**PLANNING COMMISSION AGENDA
THURSDAY, FEBRUARY 14, 2019
7:00 PM**

Subject: **Panda Express – Amend Planned Development and Site Plan Application #19-002–Request to construct an approximate 2,300 square foot Panda Express Restaurant, with one drive-through window, within the Hartland Towne Square development (Outlot #8)** Project site is located north of Highland Road (M-59), south of Hartland Square Drive, and west of Hartland Road (Tax Parcel ID #4708-21-400-074)

NORTH ELEVATION 2
Scale= 1/4" = 1'-0" A-200

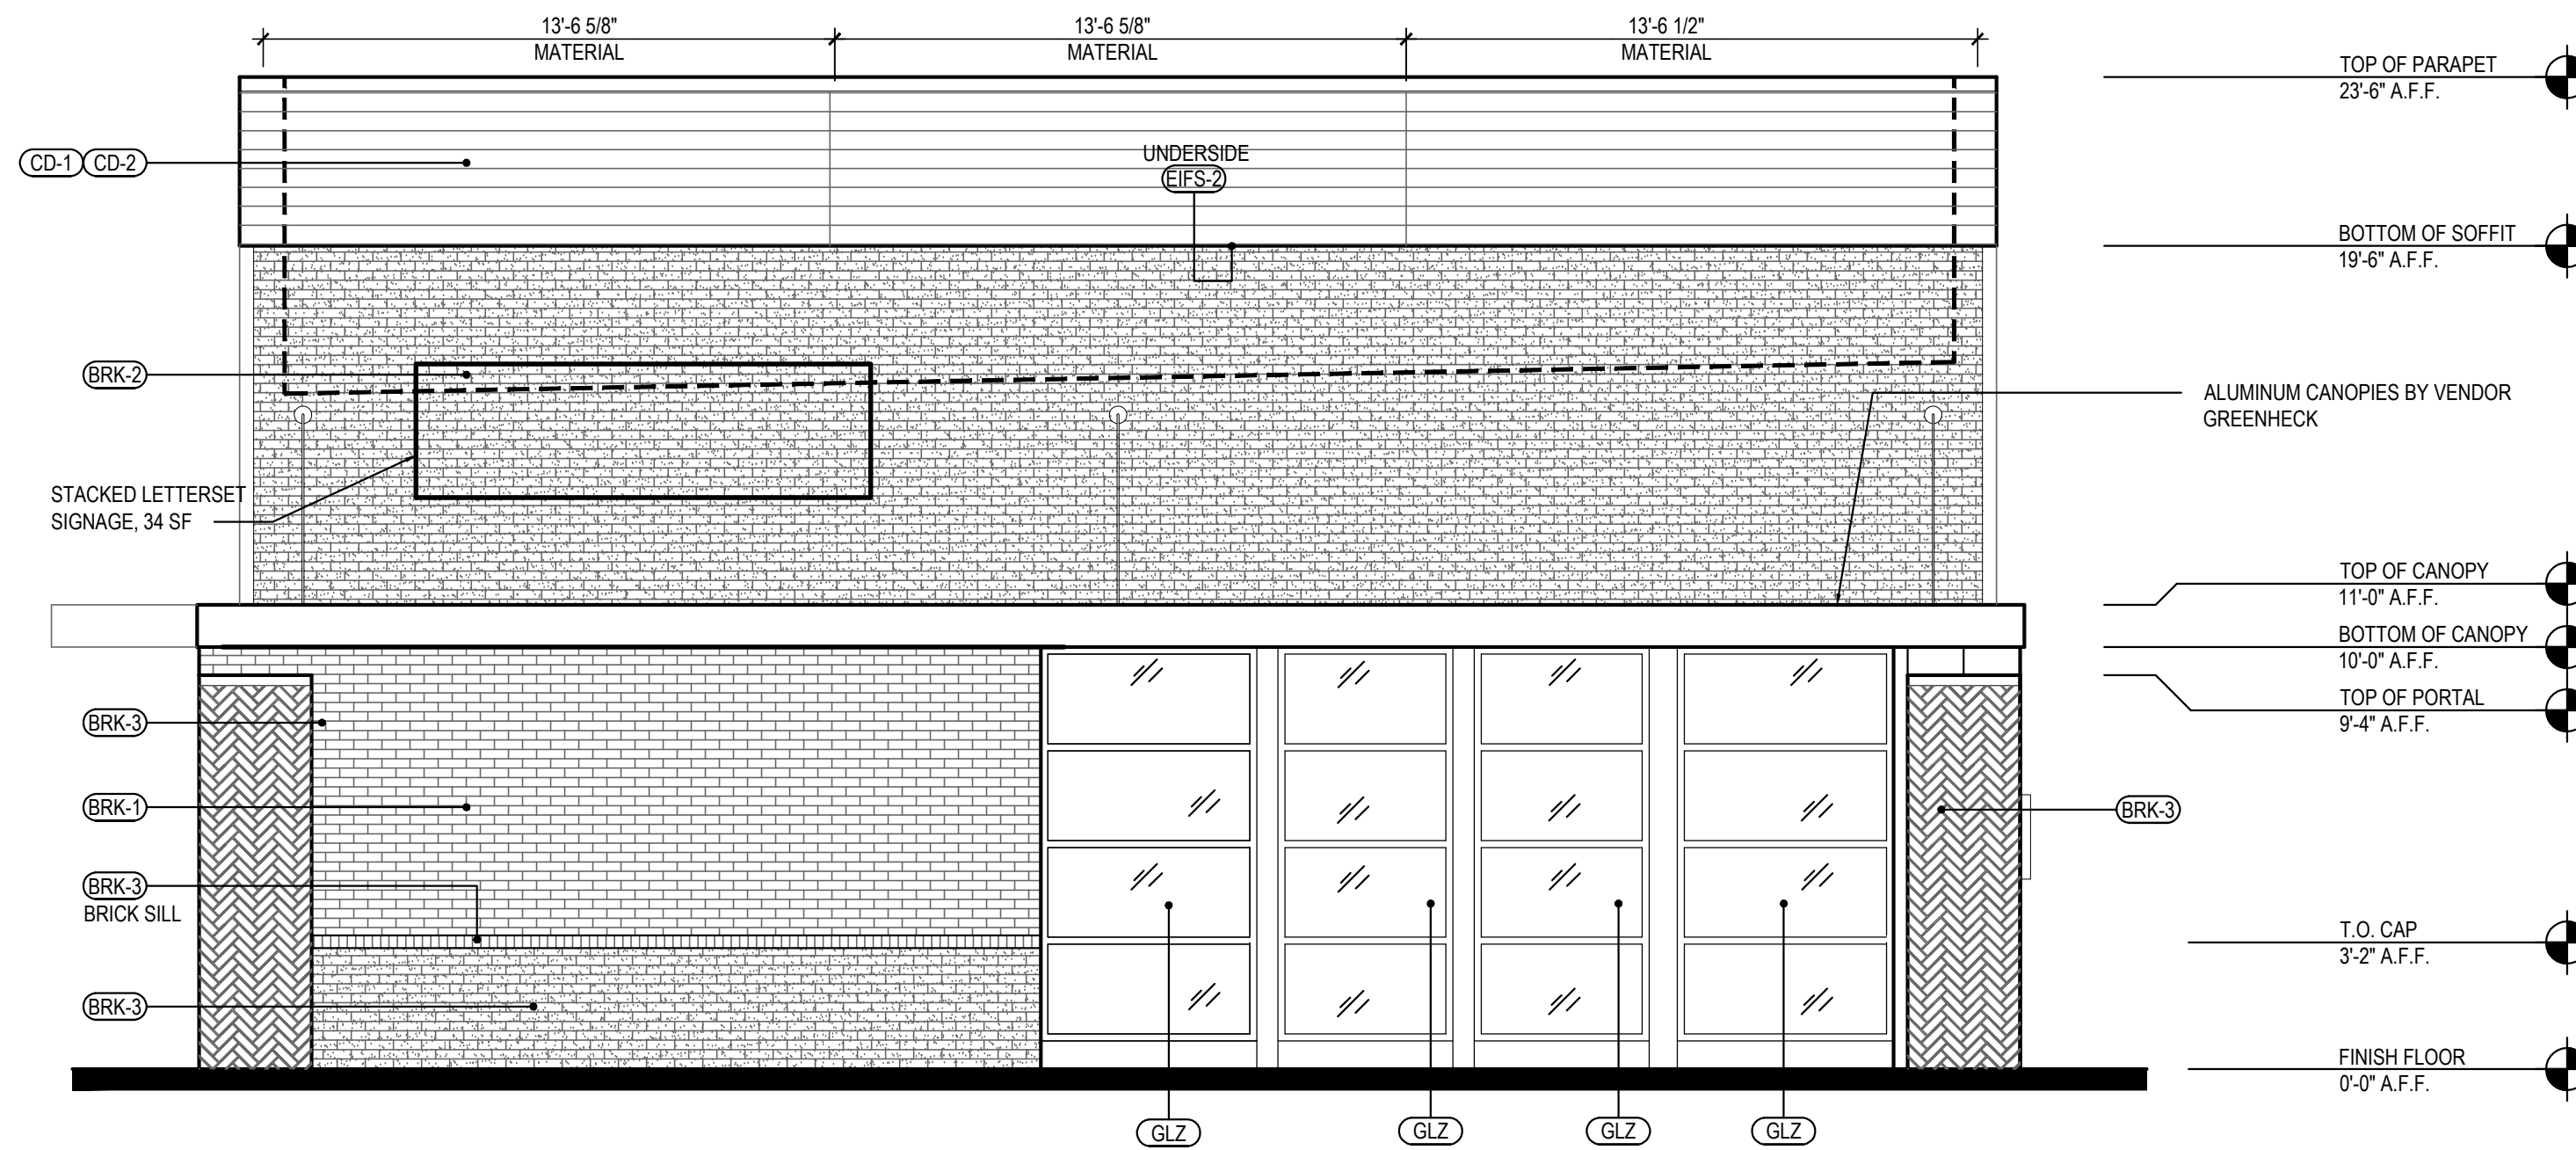
- Roof appurtenances – All rooftop equipment is to be screened behind the proposed parapet walls, per Sheet A-200 and A-201(revised elevations, PDF version only).
- Transformer (north side of building) – screening of a transformer is required. The plan shows two ornamental trees on the north side of the transformer which provides some screening. Screening of the east and north sides of the transformer with landscaping is difficult due to spatial constraints and bike racks (east of transformer).
- Bike Racks – Bike racks are provided north and east of the building and adjacent to parking.
- Ground Sign – A monument sign is not shown on the plans. The Pattern Book provides design standards for a monument sign regarding size, height and type of building

A-300
TRASH ENCLOSURE
DETAILS

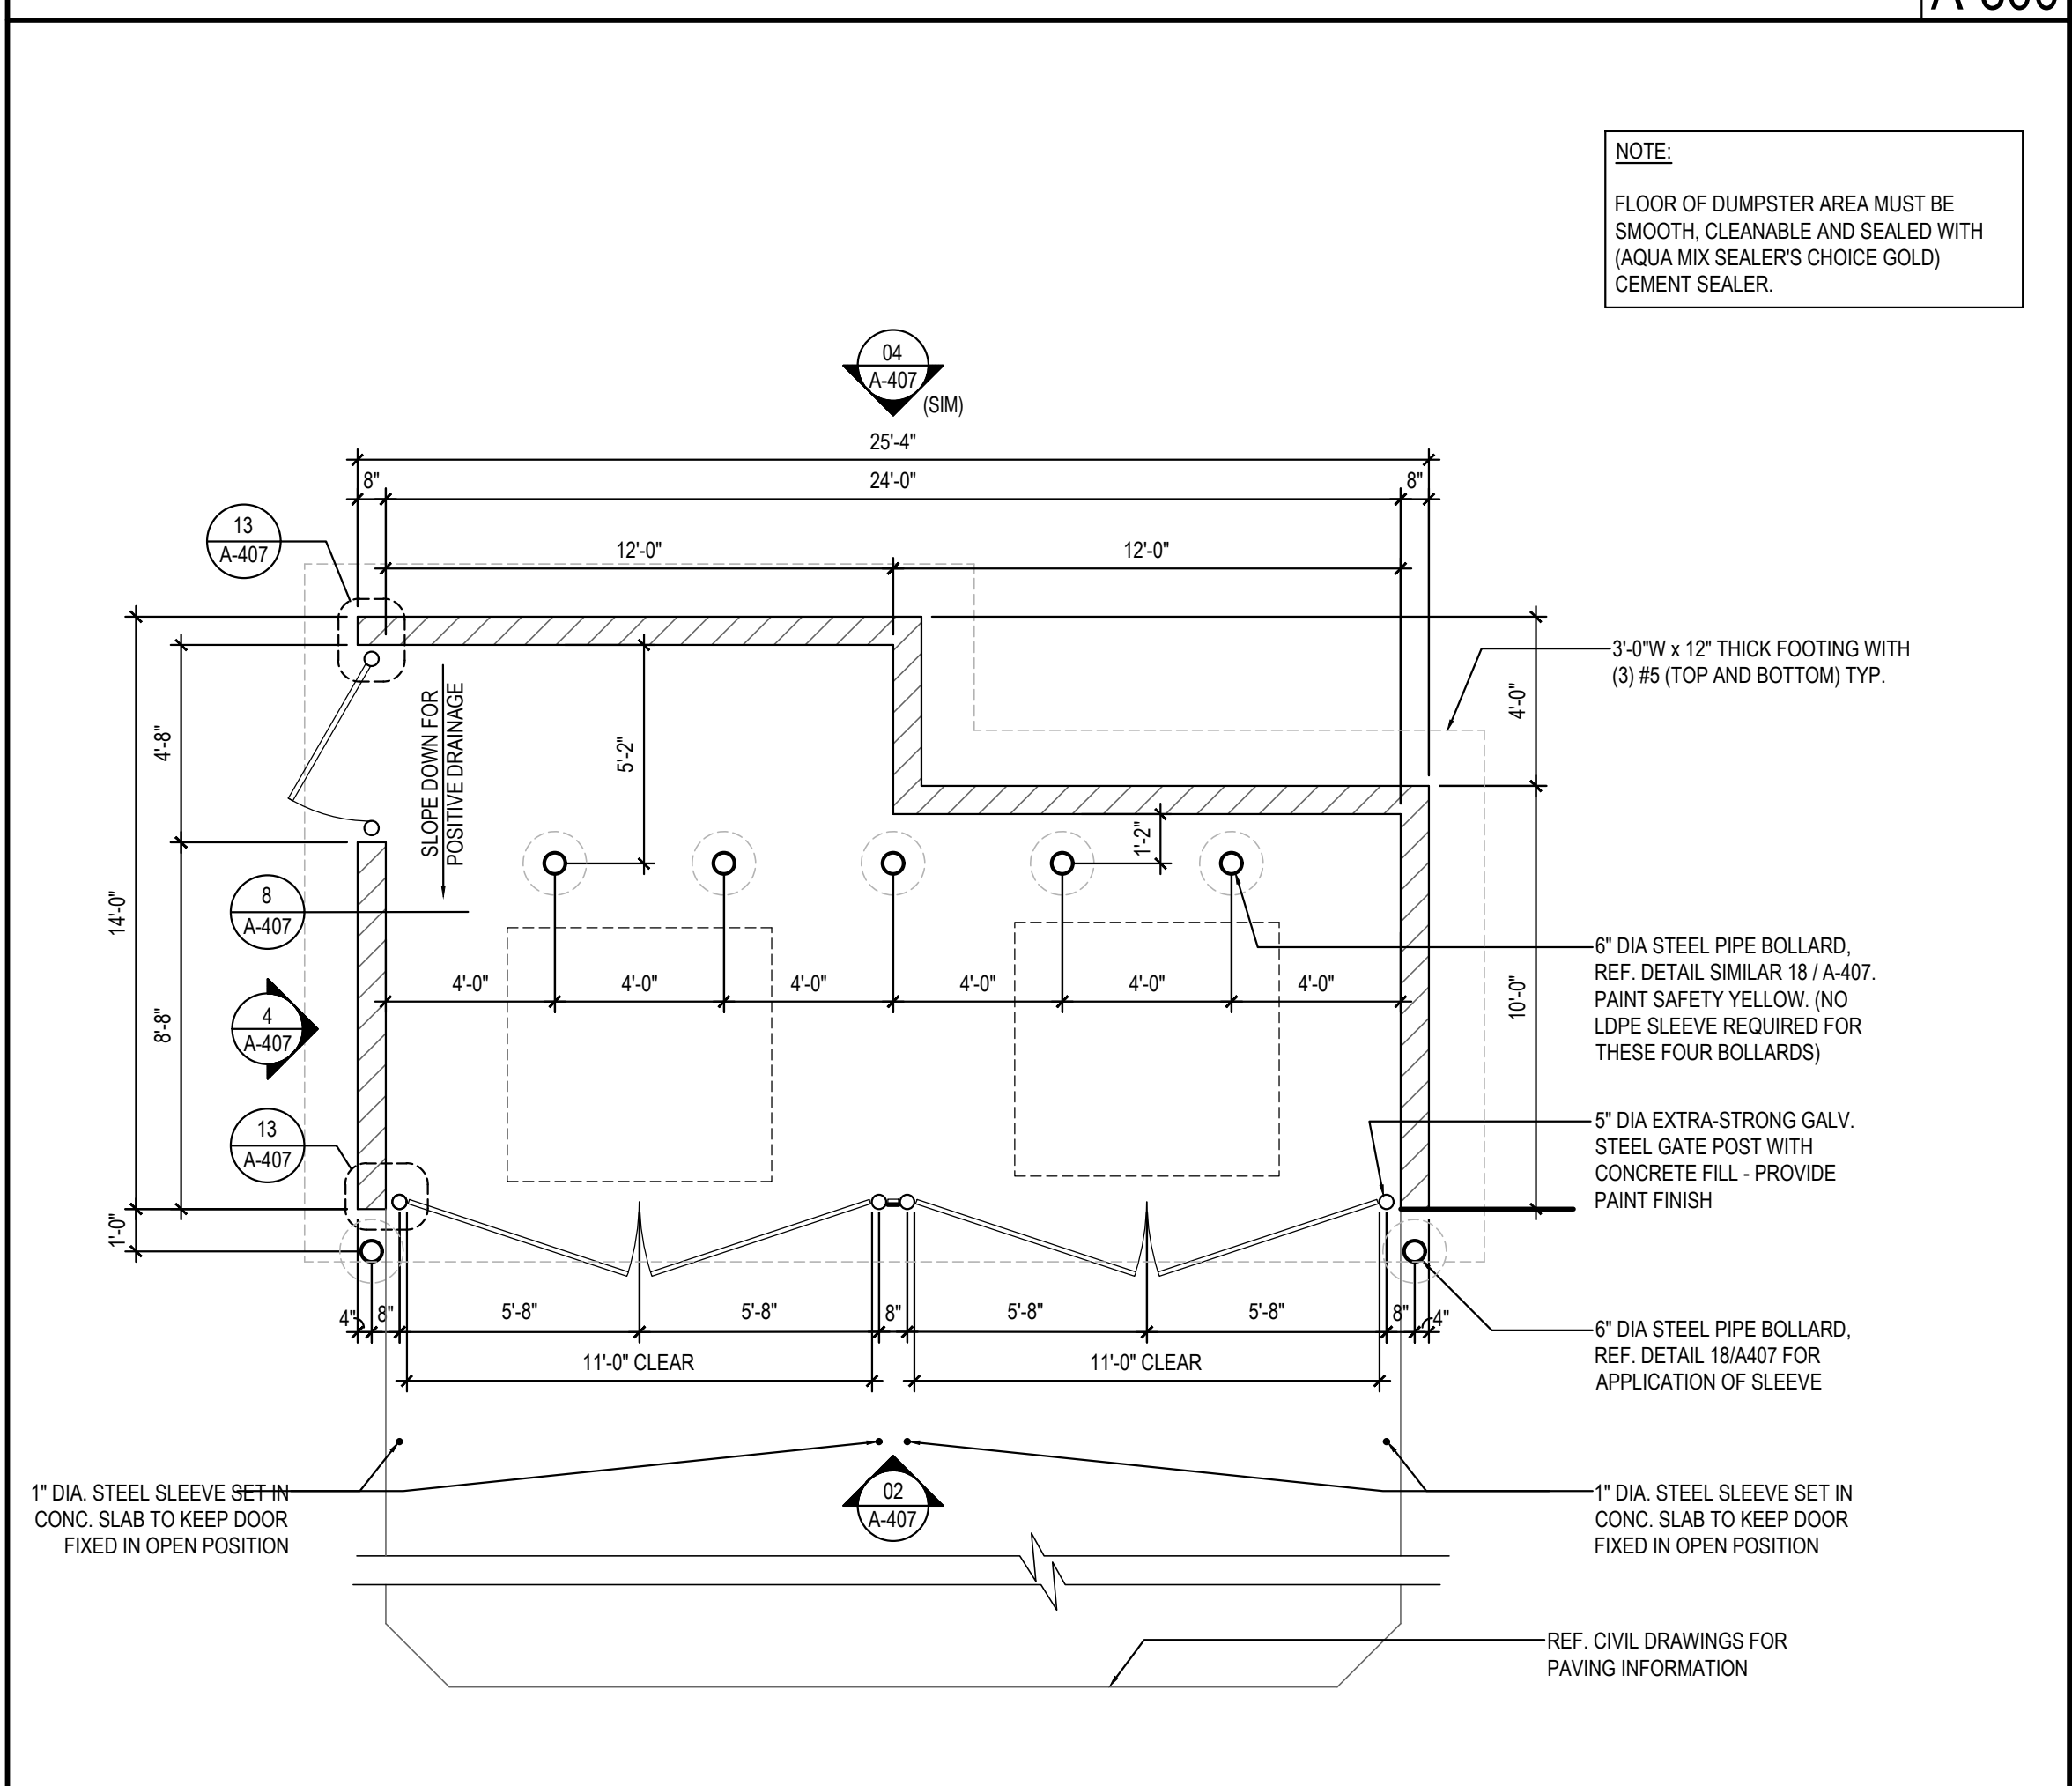
- Proposed – A screened refuse enclosure, with two stalls and gates is provided in the northwest corner of the site, with size with 6-foot high brick screen wall. The plans on Sheet A-300 indicate the trash enclosure will be constructed with EIFS finish to match the building texture.
